ITEM #4 - PRELIMINARY PLAT
Broken Axle No. 2

KPB File No.	2023-134
Plat Committee Meeting:	December 11, 2023
Applicant / Owner:	Kip Taeschner of Soldotna AK
Surveyor:	James Hall / McLane Consulting LLC
General Location:	Halibut Cove

STAFF REPORT

BROKEN AXLE No. 2

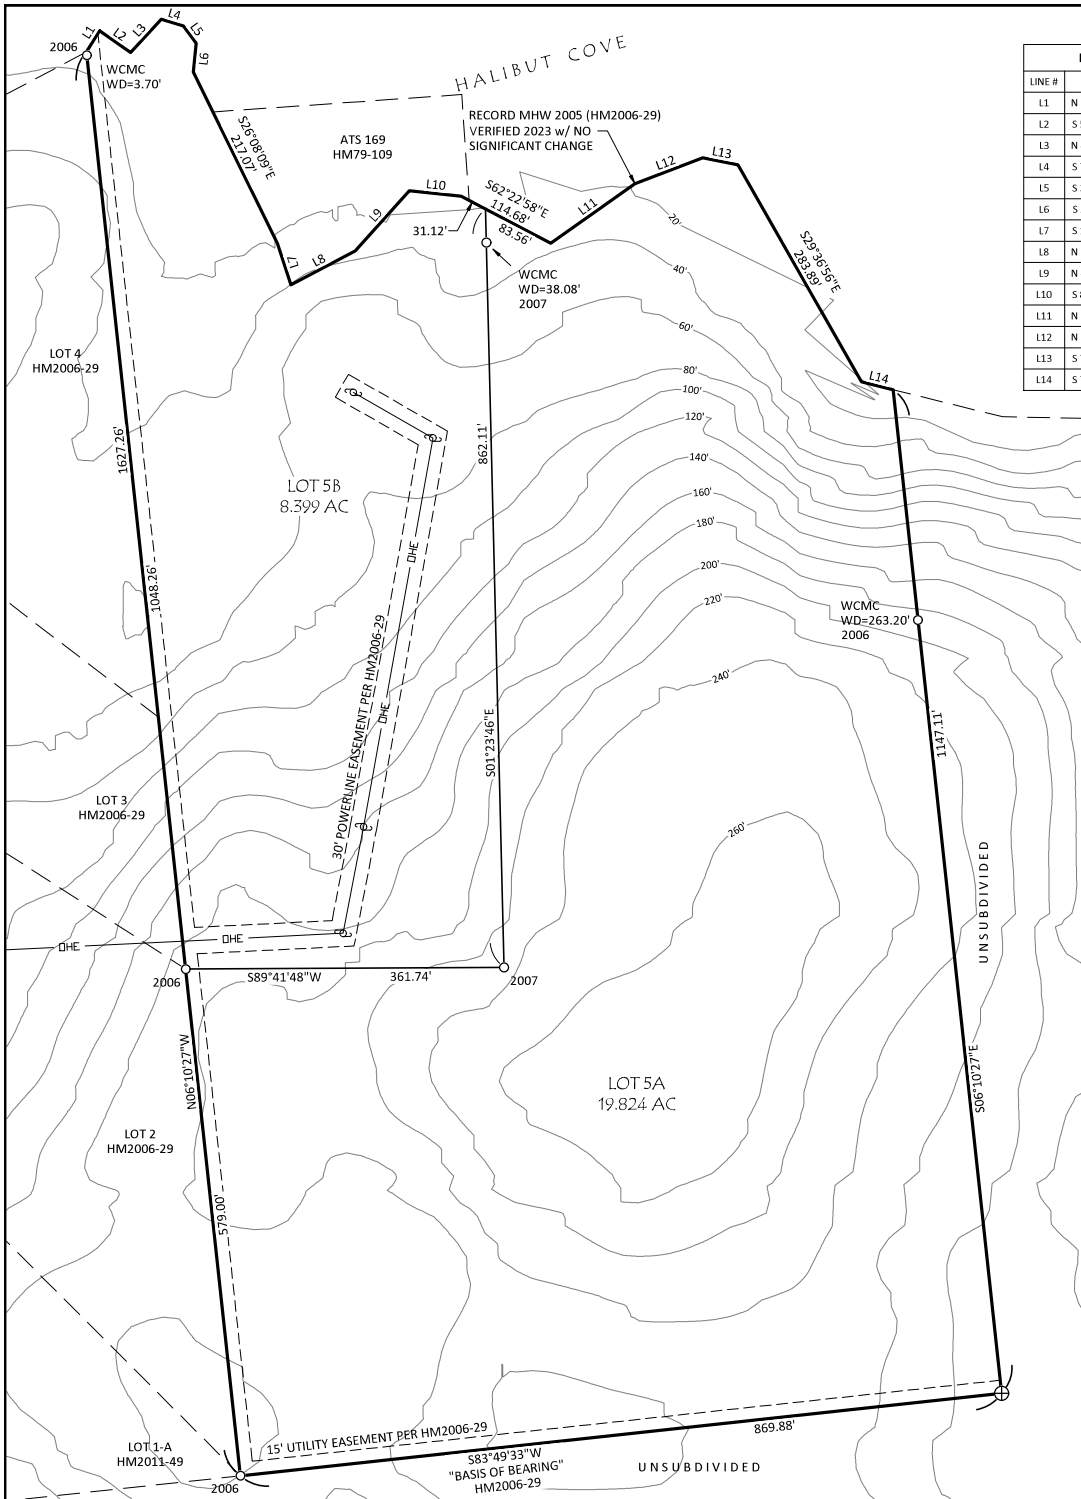
Contours have been supplied on the drawing and indicate there is steep terrain on the property. **Staff recommends:** the surveyor label on the final top and toe or steep terrain on the final and contours can be removed.

Improvements are shown on the Alaska Tidal Survey. The surveyor should locate any structures near the boundary lines for encroachment issues and if found provide a remedy for the problem.

Add 134 to KPB File no 2023-xxx

- M. Approximate locations of slopes over 20 percent in grade and if contours are shown, the areas of the contours that exceed 20 percent grade shall be clearly labeled as such;
Staff recommendation:
Top and toe / steep slope need identified on drawing.
- N. Apparent encroachments, with a statement indicating how the encroachments will be resolved prior to final plat approval;
Staff recommendation:
ATS 169 shows structures, confirm location when doing field work.

Add to the Plat Approval December 11

Change the date to 2024 on the Notary's Acknowledgement as completion is estimated to be after January 1, 2024.
